B65 '86 0801 001

SUBJECT: KINGSTON STEAM PLANT - DREDGE CELL DIKE

STABILITY ANALYSIS - RESULTS

KINGSTON FOSSIL PLANT
DREDGE CELL DIKE - TYP. SECTION

ATTACHMENT A

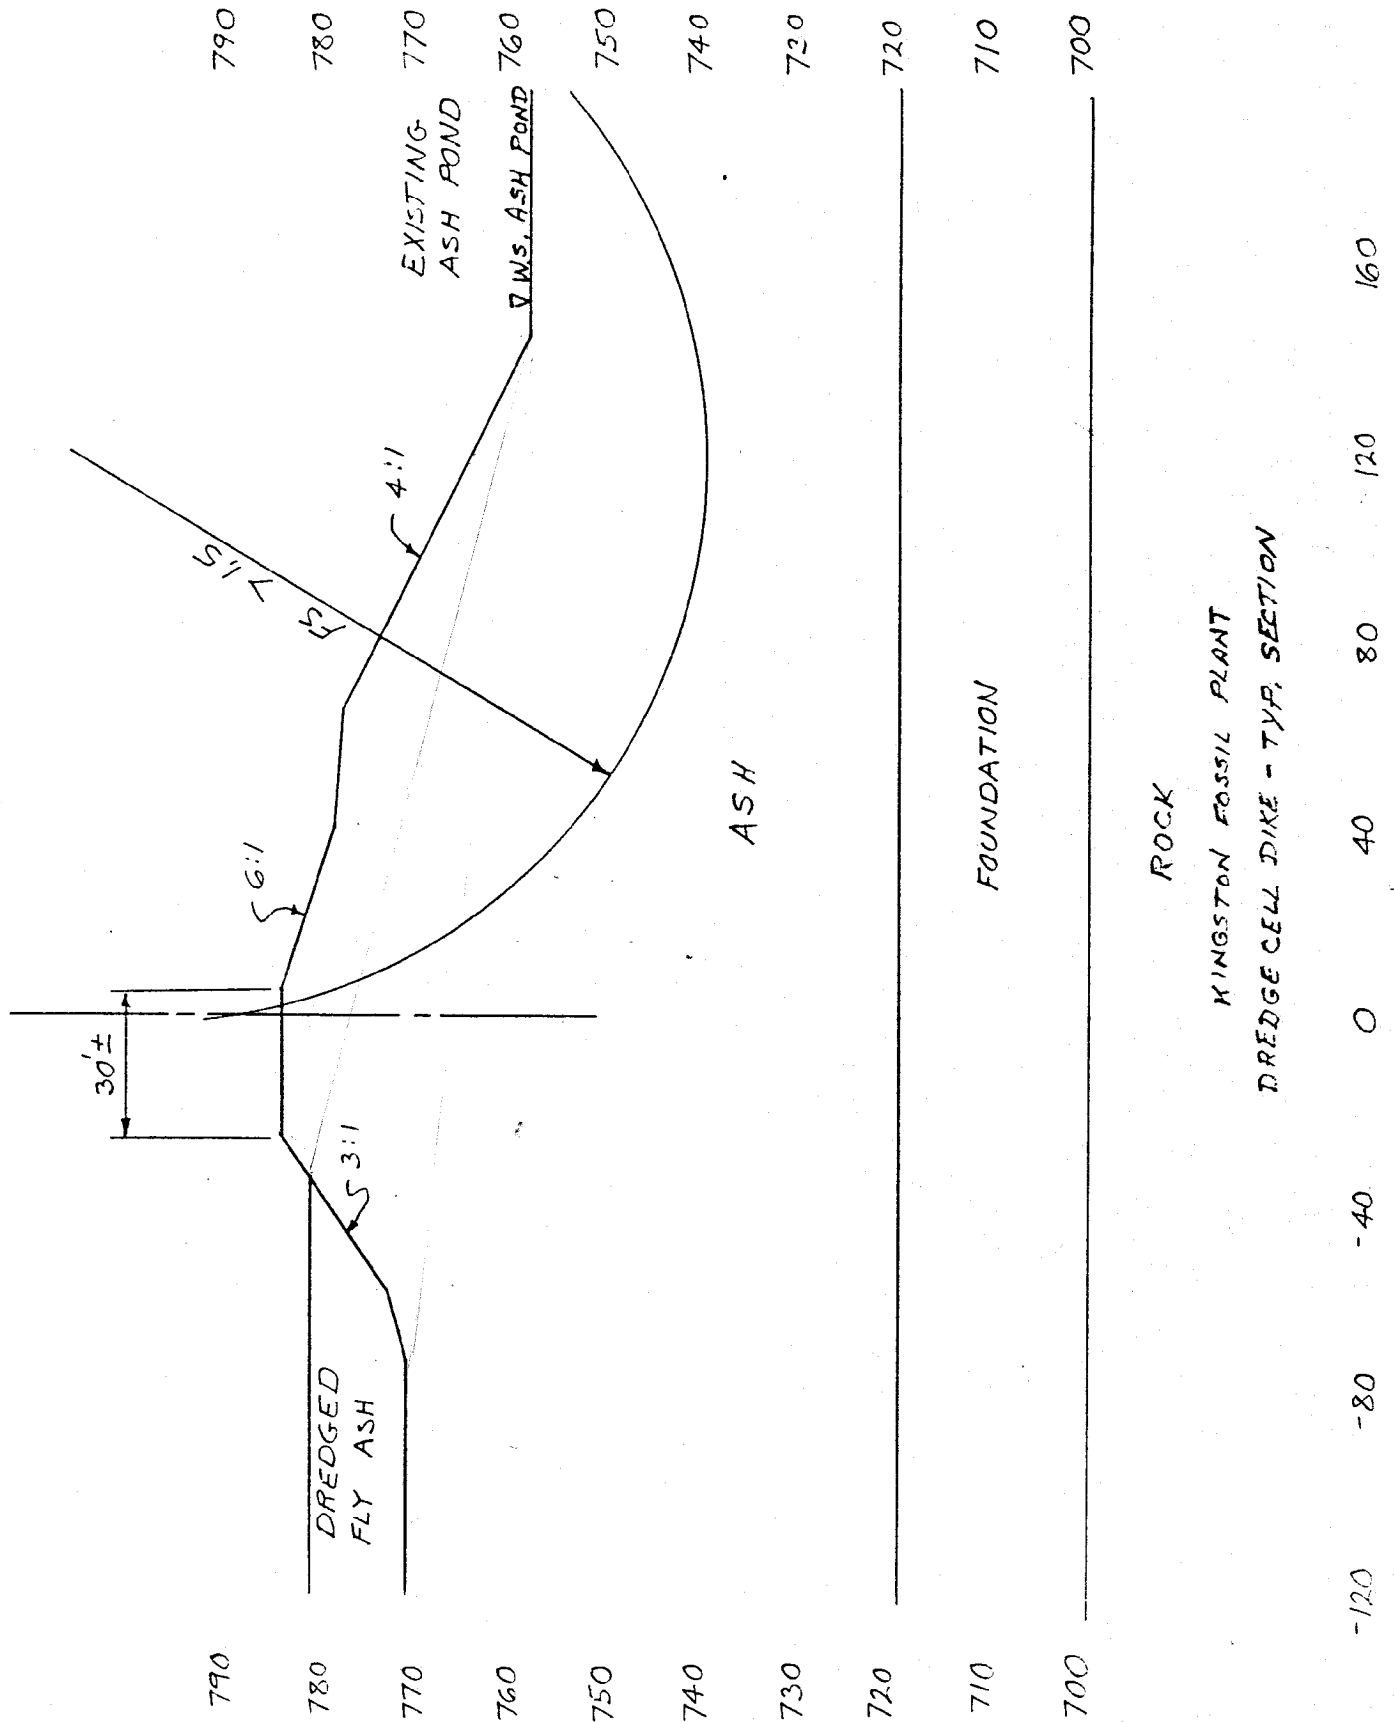
In accordance with your request, we have completed the stability analysis of the proposed typical dredge cell dike cross-section (see Attachment A) transmitted with the referenced memorandum. Our analysis indicates the factor of safety against failure exceeds 1.5 for all design cases with the assumption there will be no long-term ponding within this cell. In the event a long-term ponding condition did exist, the factor of safety would be less than 1.5.

Please note that normal operational procedures using dredge ponds recommend dewatering as soon as practical to avoid prolonged freestanding water. In addition, all ash/soil parameters were assumed utilizing historical soil investigation logs within ash pond sites and ash properties typically used for the various TVA fossil plants. Our analysis reflects these conditions.
